CITY OF PATASKALA PLANNING & ZONING COMMISSION

STAFF REPORT

Planned Manufacturing Application PM-21-004

Applicant:	Trevor Extine
Owner:	Howard P. and Rosemary A. Emswiler, Trustees
Location:	0 Etna Parkway (PID 064-152862-00.000)
Acreage:	20.02 acres
Zoning:	PM – Planned Manufacturing
Request:	Requesting approval of a Planned Manufacturing application pursuant to Section 1253.07 of the Pataskala Code to allow for the construction of an office/warehouse facility for the property located at 0 Etna Parkway (PID 064-152862-00.000).

A-100

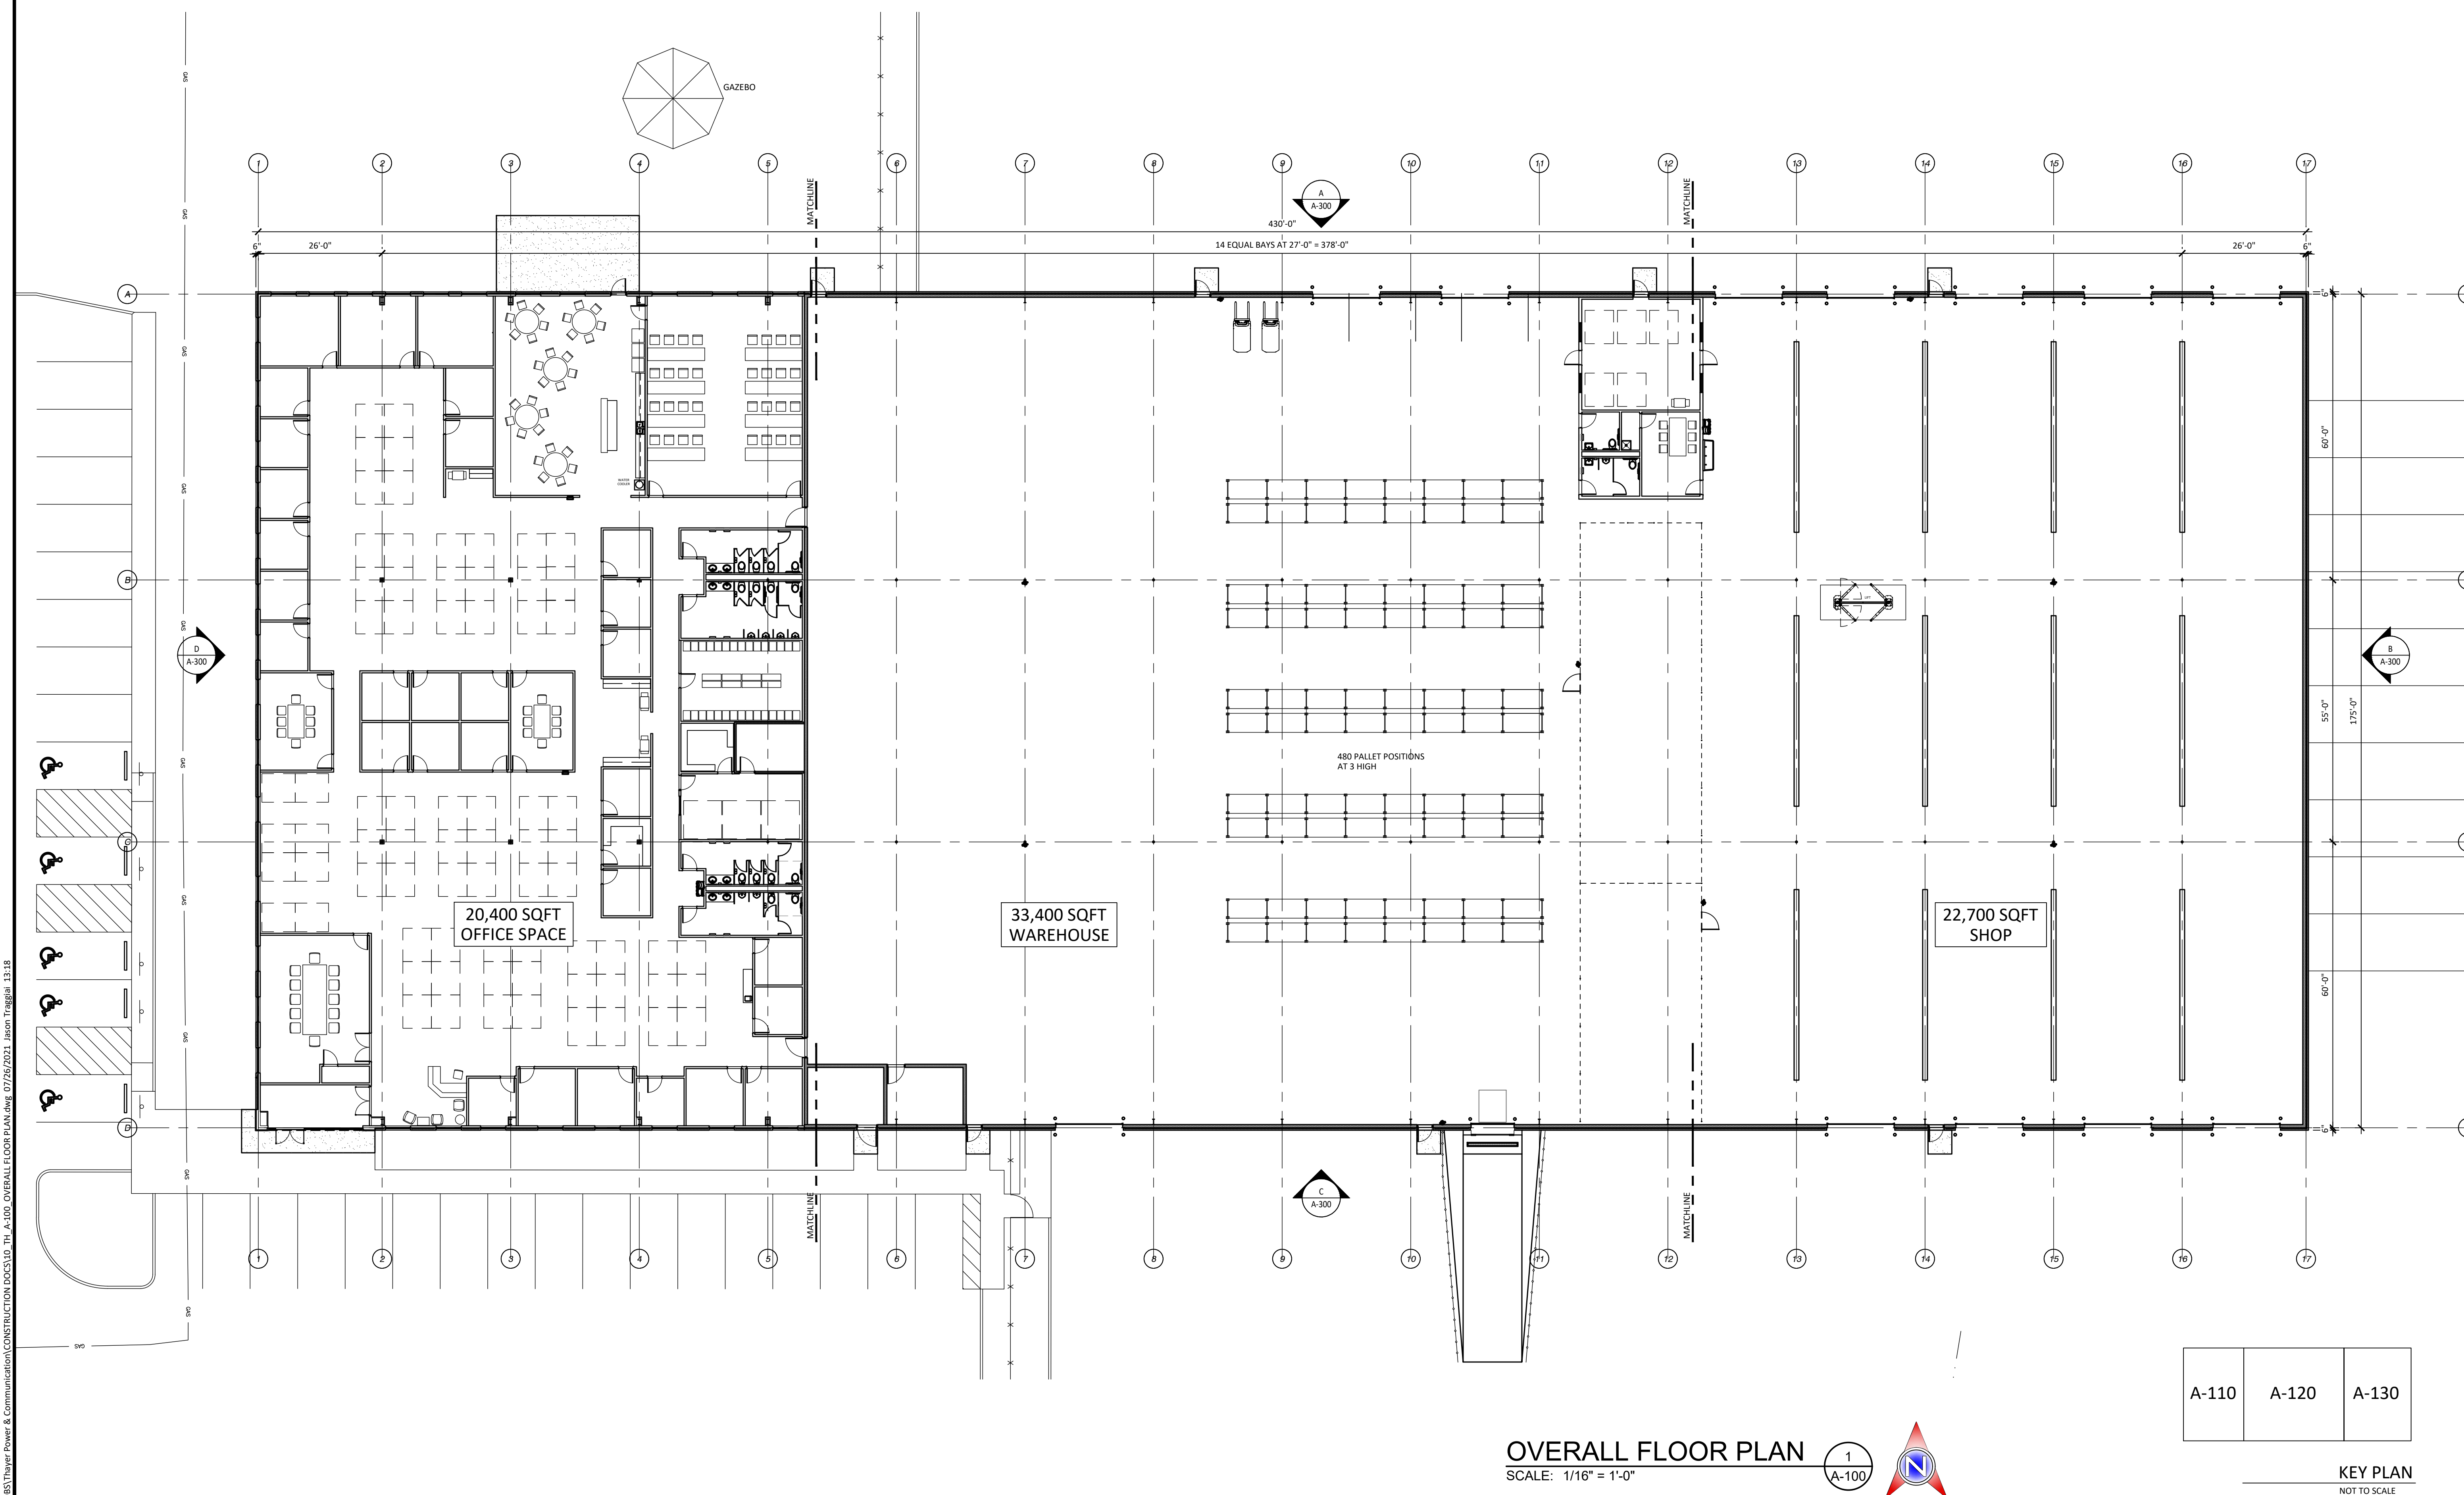
- Square Footages provided on page C102A (55,561) do not match floor plan on page A-100 (56,100)

- 1 for each 400 square feet of gross floor area.
 - Square Footages provided on page C102A (22,279) do not match floor plan on page A-100 (20,400).
 - 20,400-square foot office space/400 = 51 required parking spaces.
 - In total, 81 parking spaces are required. Calculation on C102A incorrect, please revise.
 - The plans identify only 73 total parking spaces, while 81 are required.

LANDSCAPE PLAN

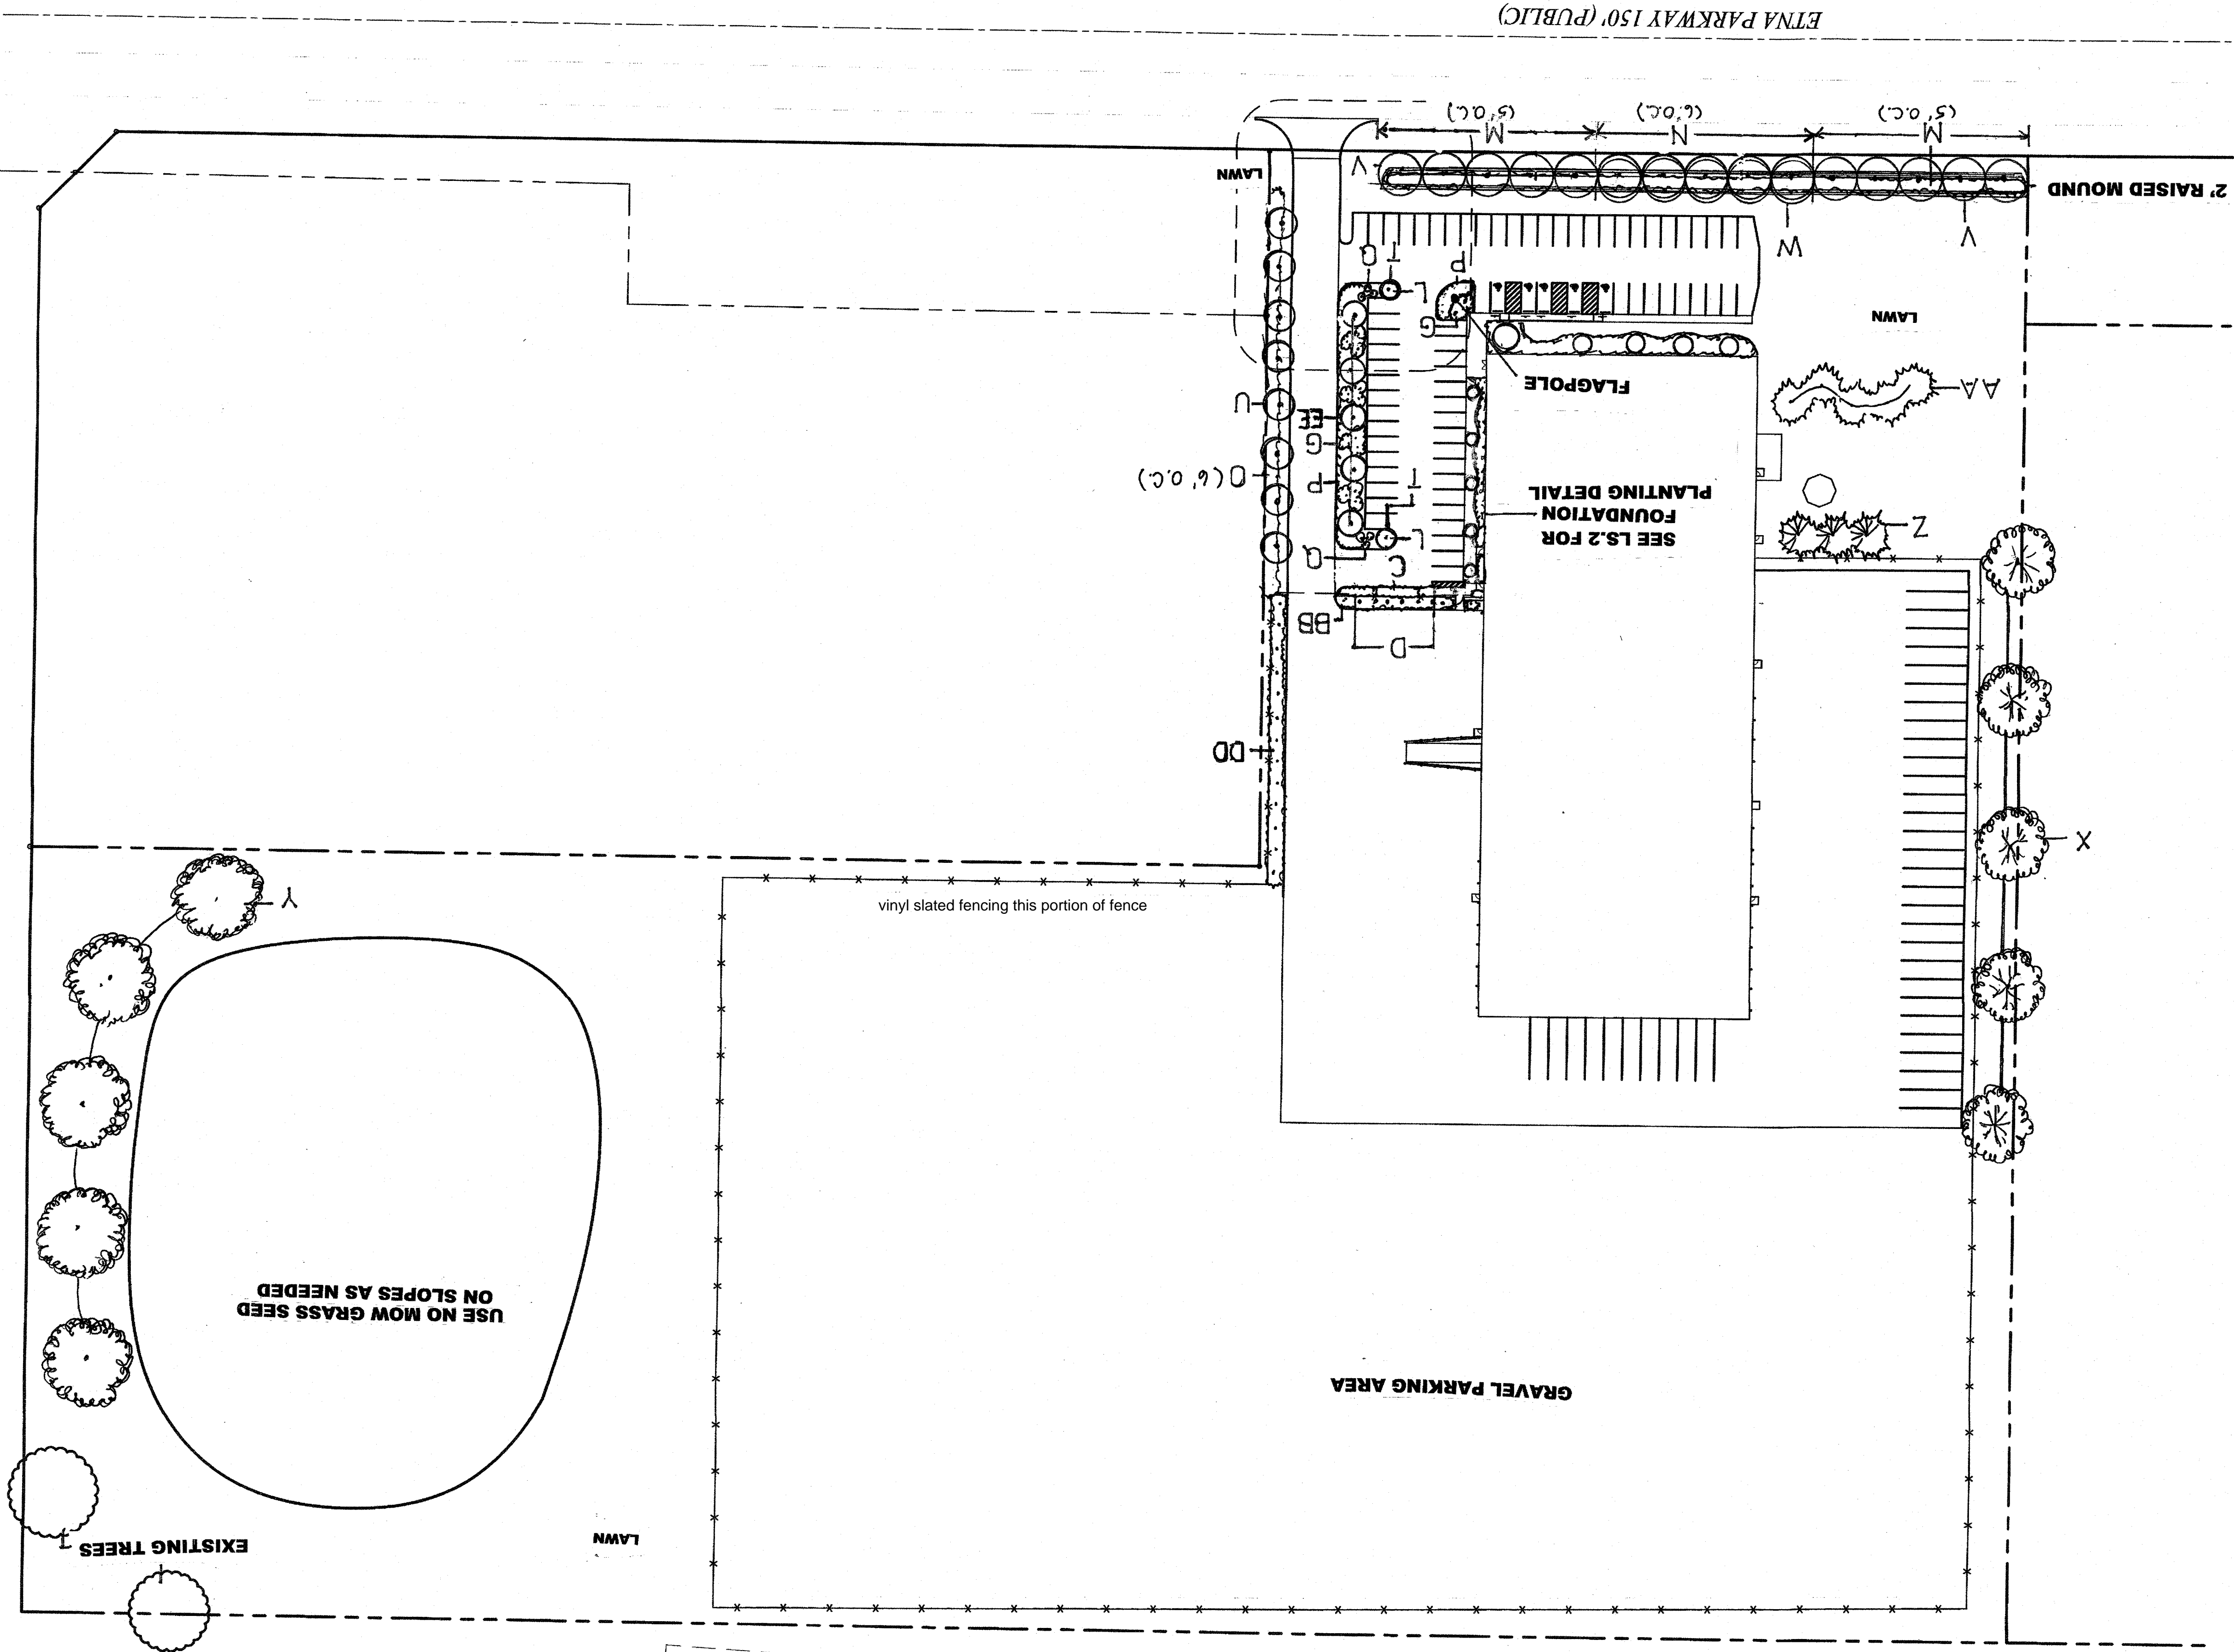
- Note: The Landscape Plans provided do not match the proposed site plans. Will need revised Landscape Plans showing the correct layout of the proposed development.

- Front Yard: **L2**
 - Etna Frontage: 2' mound with juniper plantings on top, trees at 5'-6' O.C.
 - Mix of mound and shrubs allowed as long as minimum height is 3' total, place note on plans stating shrub plantings to be minimum 1' in height.

- Need distance between trees, landscaping shall run perimeter of property line or extent of development. L2 also requires 3' high shrubs.
- South: Shrub line (6' O.C.?) with trees, unknown spacing, arborvitae along rearmost portion.
 - Unknown shrub height; must be 3' height minimum. Provide tree spacing. Arborvitae section not required by L2 but would provide more screening so that's OK.
- Southeast (Bordering Michael Shank Racing):
 - None provided.
 - L2 required.
- Rear Yard: **L2 if abutting similar use**; L5 if abutting residential use or district, L3 if abutting any district other than residential.
 - Rear (east): none provided
 - L2 required.
